TRANS/WP.29/GRSG/2004/3
23 January 2004

PROPOSAL FOR AMENDMENTS TO DOCUMENT TRANS/WP.29/GRSG/2003/25

(Proposal for 01 series of amendments to Regulation No. 66)
(Strength of superstructure of large passenger vehicles)

Transmitted by the expert from Spain

Re. annex 8, paragraph 2.2.2.

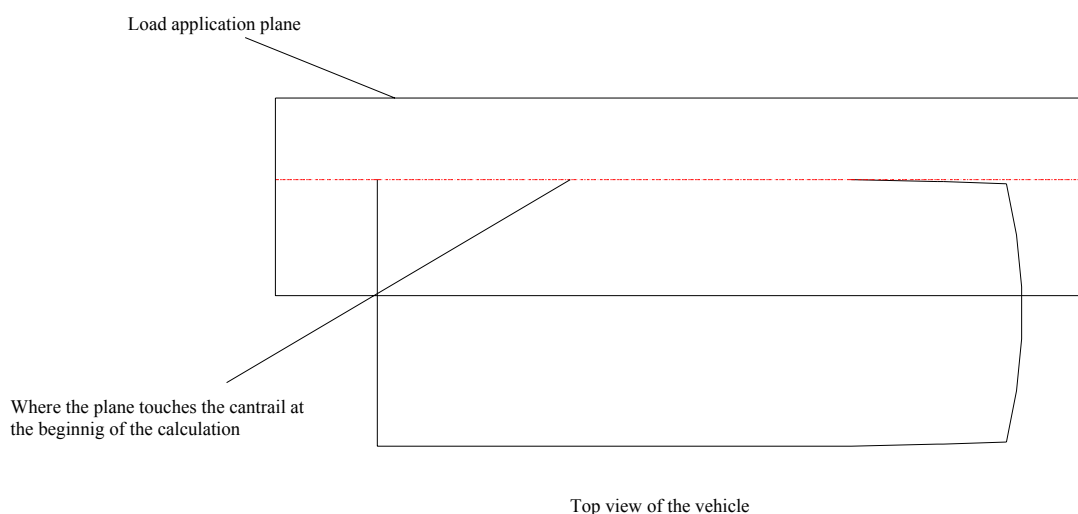
The image below explains that due to actual geometry and shape of the vehicles, at the beginning of the calculation the old paragraph 2.2.2 could not be fulfilled.

"2.2.2. At the beginning of the simulation, the load application plane touches the cantrail at its most distant part from the vertical longitudinal central plane. The contact points between the load application plane and the superstructure shall be defined to ensure an exact load transfer."
